Applicant: Christopher J. LaRiviere
Application No.: 09/260,458
Art Unit: 3725

Remarks

FIG. 2

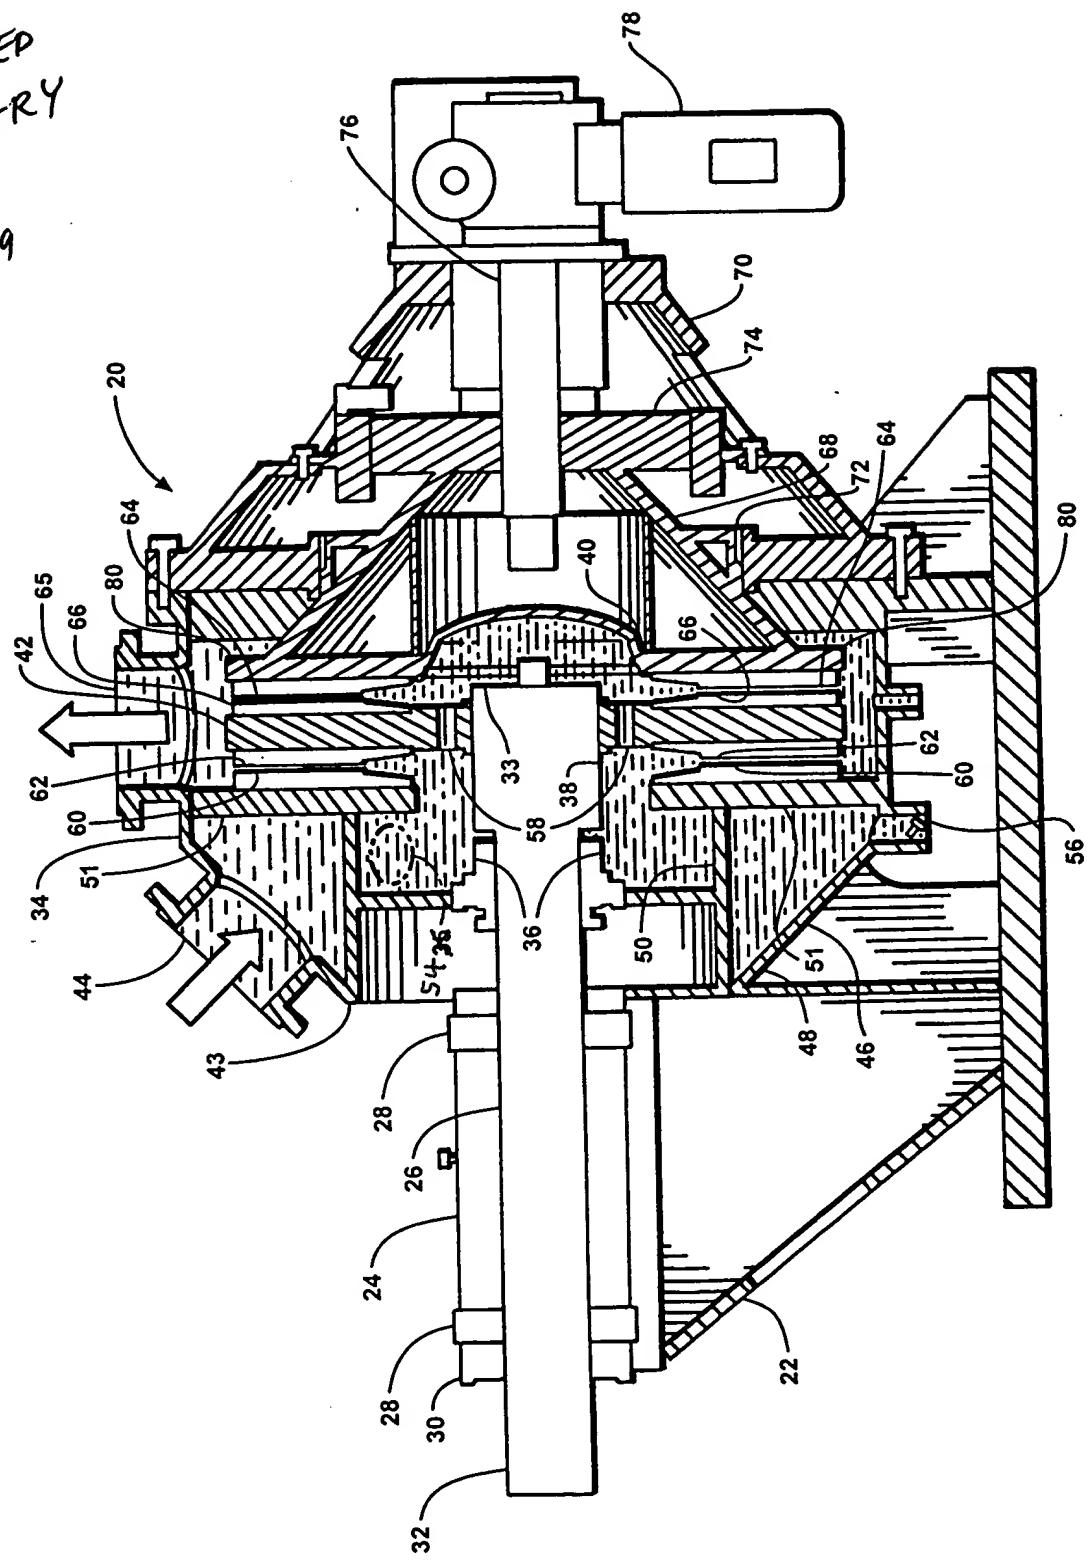
FIG. 2 incorrectly indicates the hole 54 with the call-out number 35. The drawing has been amended to supply the correct call-out number. A photoprint of FIG. 2 with the proposed change marked in red is attached. It is requested that the requirement for formal drawings be held in abeyance until such time as a Notice of Allowability is issued.
